HYUNDAI Technical Service Bulletin

25-01-091H

SUBJECT: SIDE CURTAIN AIRBAG (SCAB) INSPECTION & CORRECTION
(RECALL 289)

Description: Certain Santa Cruz (NXT), Santa Fe (MX5A), Santa Fe Hybrid (MX5A HEV), and Tucson (NX4A) vehicles equipped with Side Curtain Airbags (SCAB) may have been improperly installed, which can potentially result in abnormal airbag deployment during a crash, increasing the risk of injury to occupants. An abnormal airbag deployment could increase the risk of injury to occupants during a crash. Follow the information in this TSB to reinstall the SCAB in the correct orientation.

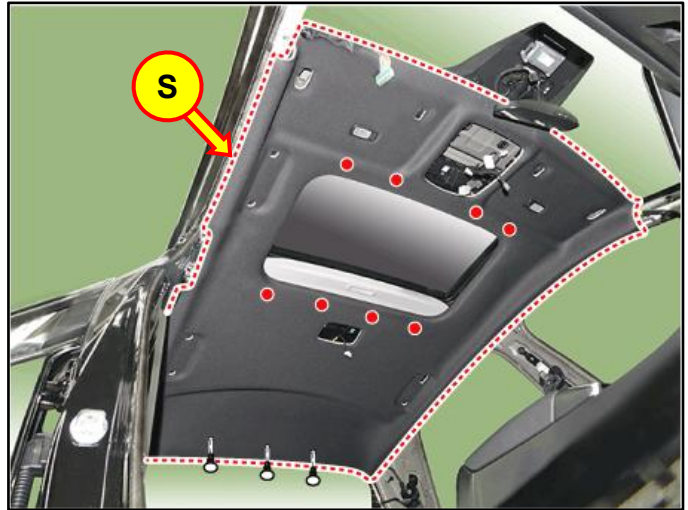
17. Visually inspect curtain airbag for twisting on both sides:

- **NOT TWISTED:** Proceed to **step 20**.
- **TWISTED:** Proceed to **step 18**.

NOT TWISTED

TWISTED

18. Remove the nuts and bolts (T, U, V, W) in alphabetical order to untwist the airbag.

19. Untwist the curtain airbag(s) then reinstall the nuts and bolts in the reverse order of the removal process, ensuring no twists are present.
